February 6, 2019

Jeanie Bourke  
Code Enforcement Officer/LPI/Plan Reviewer  
City of Portland  
Permitting and Inspections Department  
389 Congress Street, RM 315  
Portland, ME 04101

**RE: Maine Medical Center- Congress Street Tower Project  
Through Floor Firestopping T Rating Compliance Alternative**

FIGURE 1: SAMPLE SIGN AND PAINTED LINES SURROUNDING PENETRATION

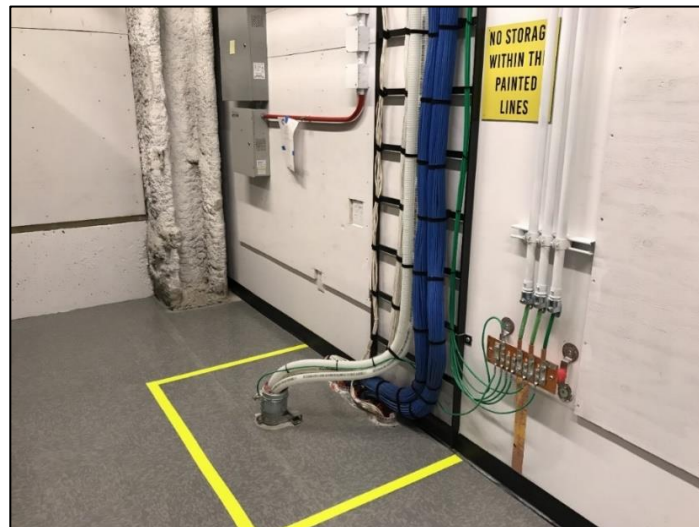
1. Permanent signage adjacent to the through-floor penetrations indicating that there shall be no storage in the area.
2. Permanent flooring or painted markings installed in a contrasting color shall be applied to the finished floor a minimum of 12" from the outer edge of the penetration. A sample of the proposed signage and marking is shown below.
